dsPIC33EVXXXGM00X/10X Family Silicon Errata and Data Sheet Clarification

The dsPIC33EVXXXGM00X/10X family devices that you have received conform functionally to the current Device Data Sheet (DS70005144H), except for the anomalies described in this document.

The following typographic corrections and clarifications are to be noted for the latest version of the device data sheet (DS70005144H):

FIGURE 1:

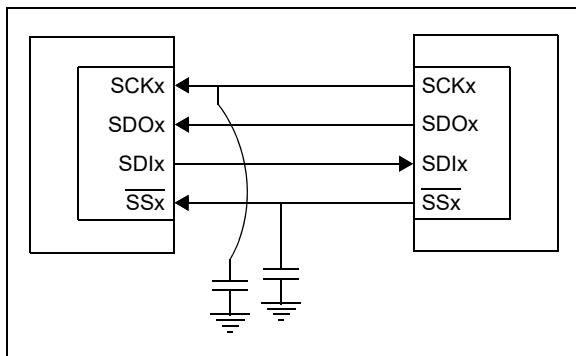
When the SPIx module is configured in SPIx Client mode (MSTEN bit (SPIxCON1[5]) = 0), the frame client (FRMEN bit (SPIxCON2[15]) = 1) and the SPIFSD bit (SPIxCON2[14]) = 1, in Standard Buffer mode with the Clock Polarity Select bit, CKP = 0, the data are not transmitted in both 8-bit and 16-bit mode, but the data are being received correctly.

Adding a capacitance on the signal, as shown in Figure 1, will help the data to be received properly.

FIGURE 2: TIMING DIAGRAMS FOR CENTER-ALIGNED AND EDGE-ALIGNED MODES

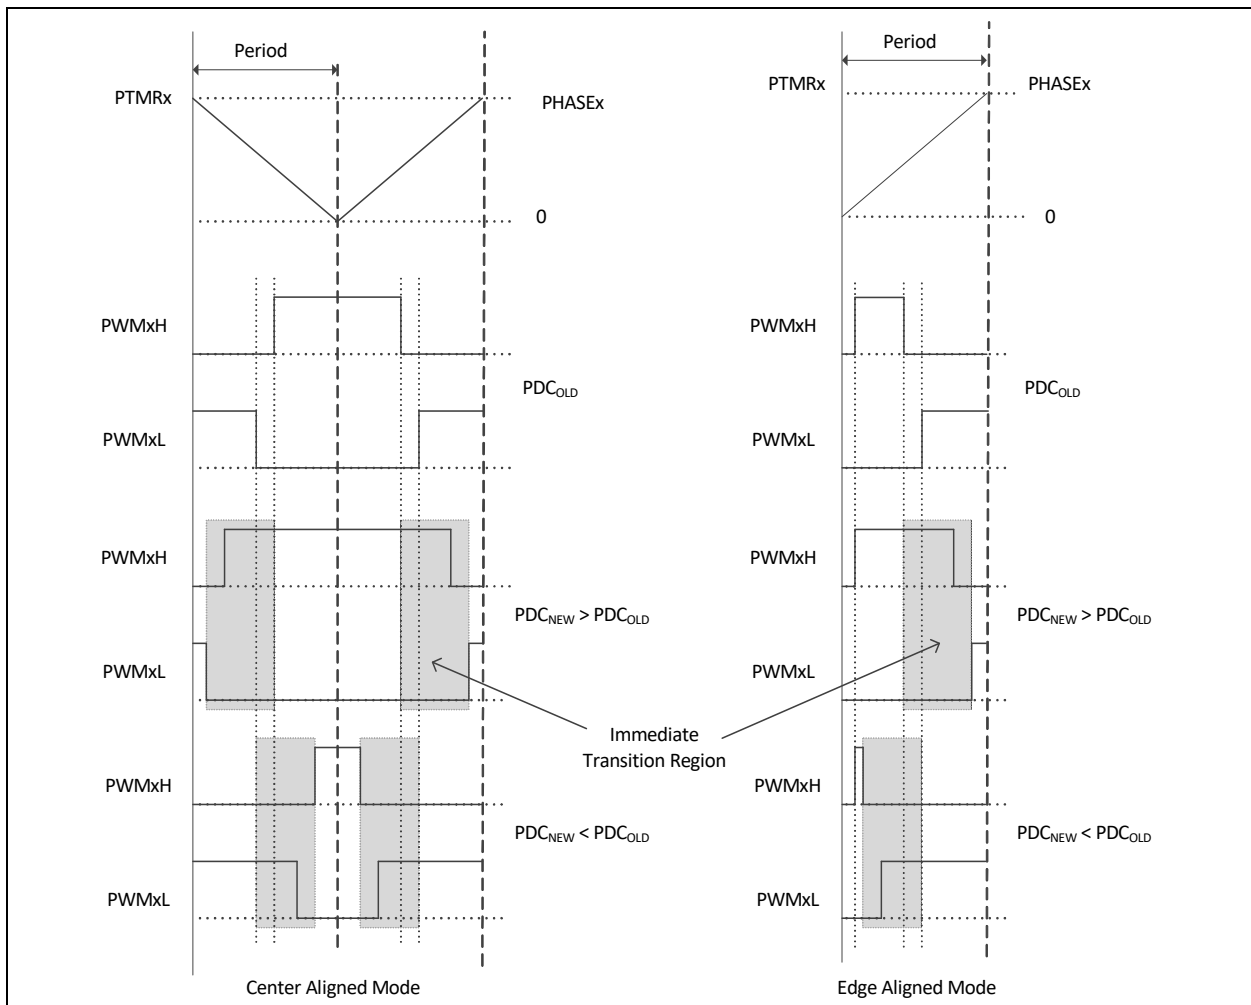
The PWM generator may not assert dead time on the edges of transitions. This has been observed when all of the following conditions are present:

- The PWM generator is configured to operate in Complementary mode with Independent Time Base (ITB) or host time base;
- Immediate update is enabled; and
- The value in the PDCx register is updated in such a manner that the PWMxH and PWMxL outputs make an immediate transition.

In [Figure 2](#), if the duty cycle write occurred in the shaded box, then PWMxH and PWMxL will make an immediate transition without dead time.

However, in most applications, the duty cycle update timing can be controlled using the TRIGx trigger or Special Event Trigger, such that the above mentioned conditions are avoided altogether.

FIGURE 3: ILLUSTRATION OF 1 TOSC GLITCH WHEN PWM OVERRIDE IS TURNED OFF

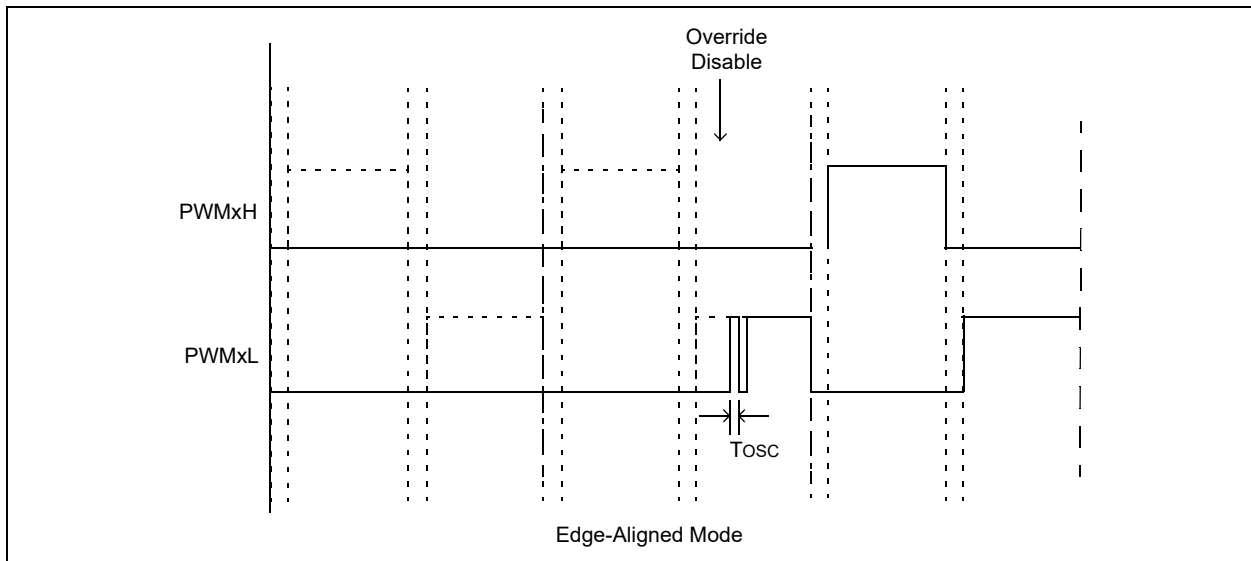
In Complementary mode after the PWM module is enabled (PTEN = 1), if the PWM override is turned off, a one TOSC glitch will be present on the rising edge of either the PWMxH or PWMxL pins, whichever occurs first, as shown in Figure 3.

The glitch will be present on PWMxH/PWMxL every time the override state is changed from override enabled to override disabled. The width of this glitch is equal to one TOSC when PCLKDIV[2:0] (PTCON2[2:0]) = 000. Increasing the PWMx input clock prescaler setting will increase the width of the glitch accordingly.

FIGURE 4:

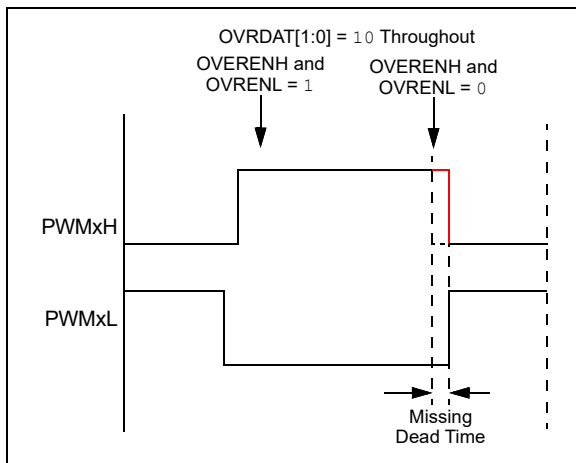
In Complementary Output mode, the expected dead time between transitions of the PWMxH and PWMxL outputs may not be asserted when the following occurs:

- Output override synchronization is configured to occur on the CPU clock boundary (IOCONx[0] = 0);
- Both PWMxH and PWMxL overrides are enabled prior to the event (OVRENH and OVRENL are both '1'), and
- Both overrides are disabled (OVRENH and OVRENL are both '0') at the instant the dead time should be asserted (Figure 4). This has been observed in both Center-Aligned and Edge-Aligned modes.

FIGURE 5:

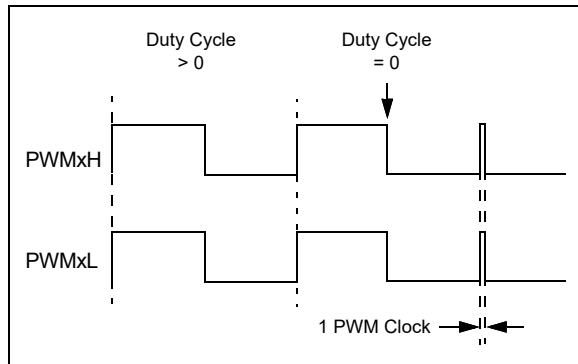
In the Redundant Output mode (IOCONx[11:10] = 10) and Push-Pull Output mode (IOCONx[11:10] = 01) with Immediate Update disabled (PWMCONx[0] = 0), when the Duty Cycle register is updated from a non-zero value to zero, a glitch pulse of a width equal to one PWM clock will appear at the next PWM period boundary, as shown in Figure 5, for the Redundant Output mode. Here, the Duty Cycle register refers to the PDCx register if PWMCONx[8] = 0 or the MDC register if PWMCONx[8] = 1.

If the application requires a zero duty cycle output, there are two possible work around methods:

1. Use the PWM override feature to override the PWM output to a low state instead of writing to the Duty Cycle register. In order to switch back to a non-zero duty cycle output, turn off the PWM override. The override-on and override-off events must be timed close to the PWM period boundary if the IOCONx register has been configured with IOCON[0] = 0 (i.e., output overrides via the OVDDAT[1:0] bits occur on the next CPU clock boundary).

2. Enable the Immediate Update (PWMCONx[0] = 1) while configuring the PWM module, i.e., before enabling the PWM module (PTCON[15] = 1). With Immediate Update enabled, writes to the Duty Cycle register can have an immediate effect on the PWM output. Hence, duty cycle write operations must be timed close to the PWM period boundary in order to avoid distortions in the PWM output.

FIGURE 6:

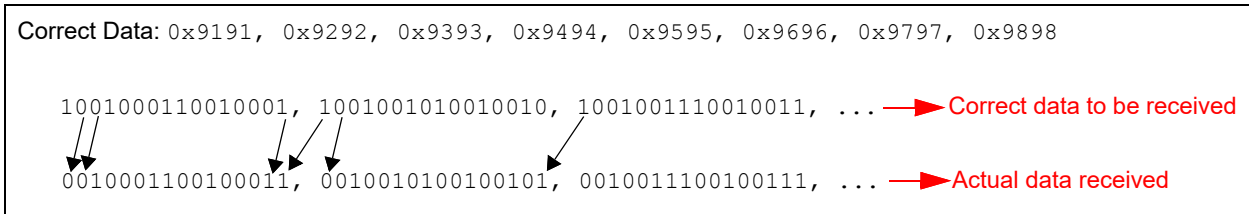
Received data of the SPI are sampled one clock cycle late for the following conditions:

1. When the SPI is configured as host (MSTEN = 1), frame sync pulse input (SPIFSD = 1), enhanced buffer (SPIBEN = 1), CKP = 1, SMP = 1, FRMPOL = 1 and FRMDLY = 1.
2. When the SPI is configured as host (MSTEN = 1), frame sync pulse input (SPIFSD = 1), enhanced buffer (SPIBEN = 1), CKP = 1, SMP = 1, FRMPOL = 0 and FRMDLY = 0.

For example, the correct data that should be received are 0x9191, 0x9292, 0x9393, 0x9494, 0x9595, 0x9696, 0x9797, 0x9898, but the actual data received are 0x2323, 0x2525, 0x2727, 0x2929, 0x2B2B, 0x2D2D, 0x2F2F, 0x3130 (Figure 6).

FIGURE 7: SIMPLIFIED BEHAVIOR

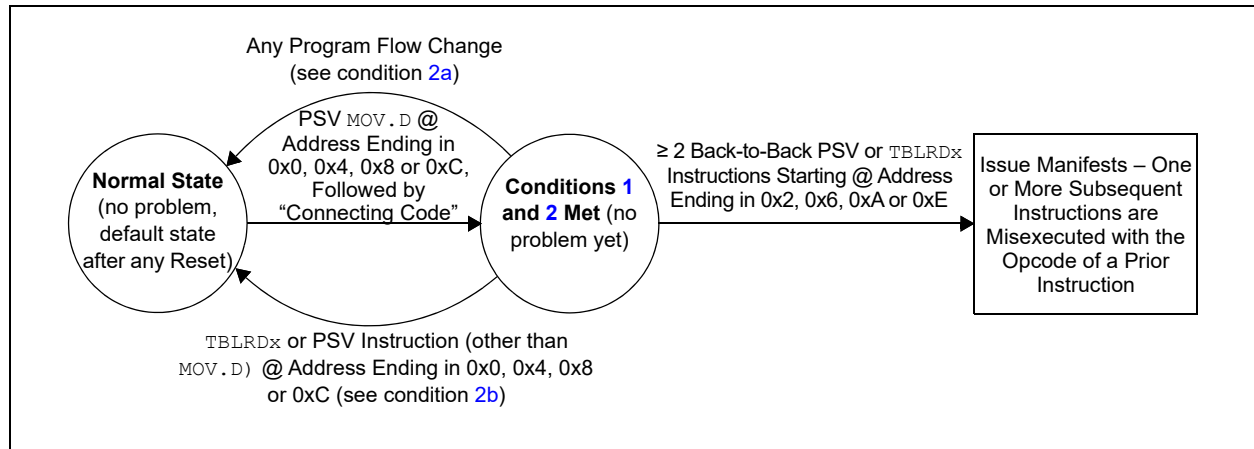
3.	≥ 2 back-to-back PSV or <code>TBLRDx</code> instructions are executed (following the code of condition 2), where the first of the back-to-back instructions is located at an address ending in 0x2, 0x6, 0xA or 0xE.

[Figure 7](#) provides an example of the effective behavior.

1. All instances of PSV MOV.D can be replaced with two PSV MOV instructions instead. Non-PSV MOV.D instructions acting on RAM/SFRs do not need to be modified; or
2. If not already present, a program flow change instruction (such as BRA \$+2) can be inserted above back-to-back data Flash read sequences; or
3. Back-to-back data Flash read instruction sequences can be broken up by inserting a non-Flash read instruction (such as a NOP), in between the Flash read instructions; or
4. The alignment of the code can be shifted to avoid the required opcode location addresses.

C code built with MPLAB® XC16 Compiler Version 1.32, or later, implements the work around by default. However, if the application uses Assembly language routines, these should be manually modified to implement the work around. Additionally, if precompiled libraries are used, these should be built with XC16 Version 1.32 or later. For additional information, please visit: www.microchip.com/erratum_psrds_psrds

64-Lead Plastic Quad Flat, No Lead Package (MR) – 9x9x0.9 mm Body with 5.40 x 5.40 Exposed Pad [QFN]

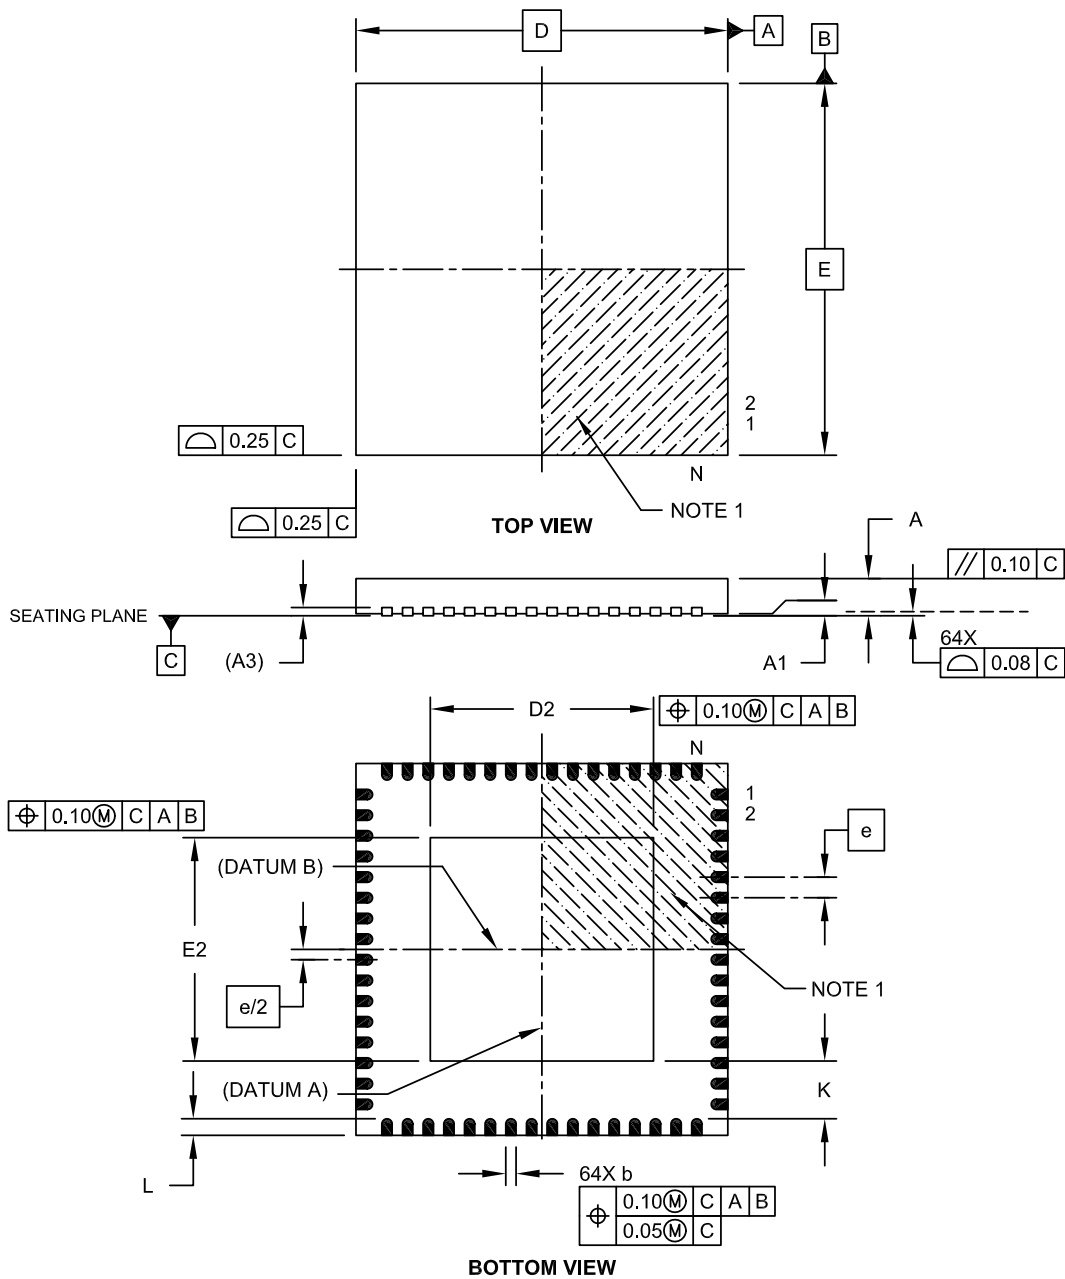
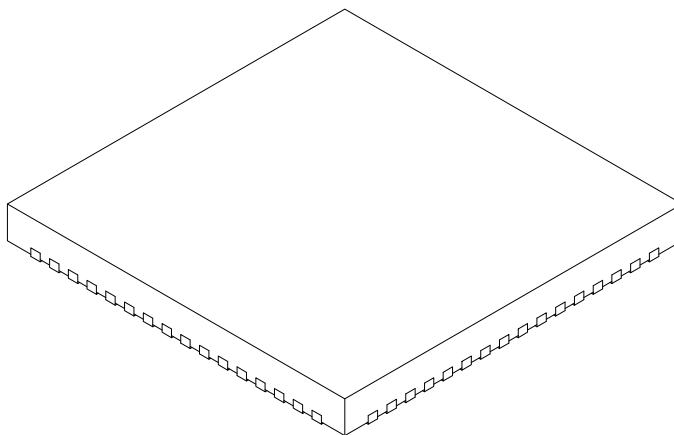
The package drawing for the 64-pin QFN device has been updated with the 64-Lead Plastic Quad Flat, No Lead package (MR) – 9x9x0.9 mm Body with 5.40x5.40 Exposed Pad [QFN] package drawing as shown below.

Figure 24-3. ADC Input Model

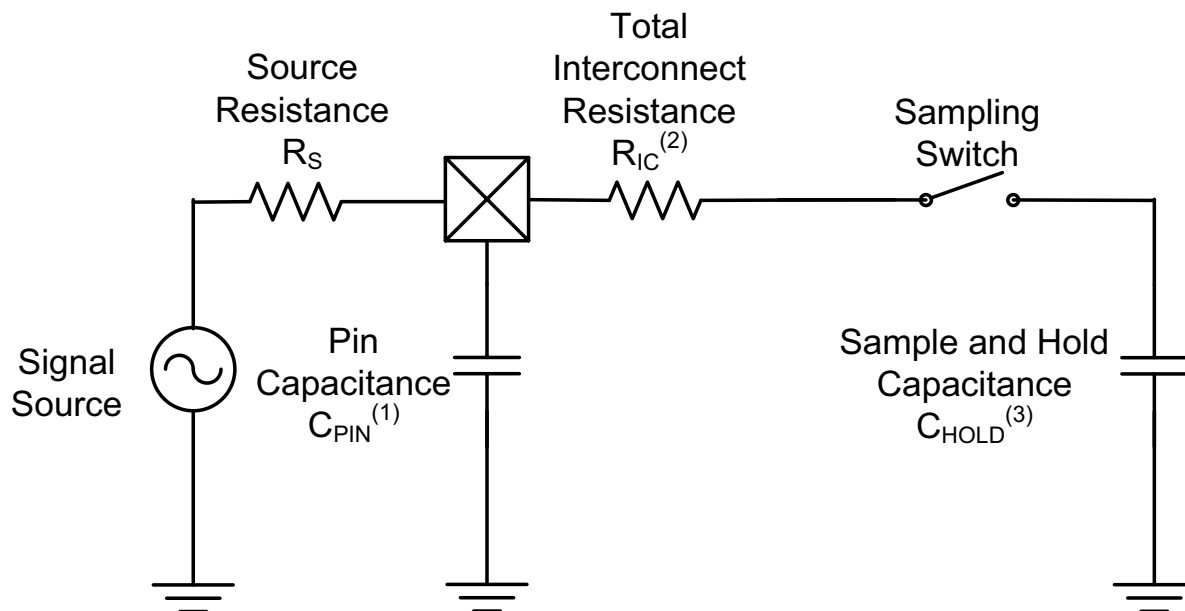
Section 24.1.3 Sampling Time Requirements is added as bellow:

The analog input model of the ADC is illustrated in Figure 24-3.

$$TSAMPLING = 9 \times RTOTAL \times CHOLD$$
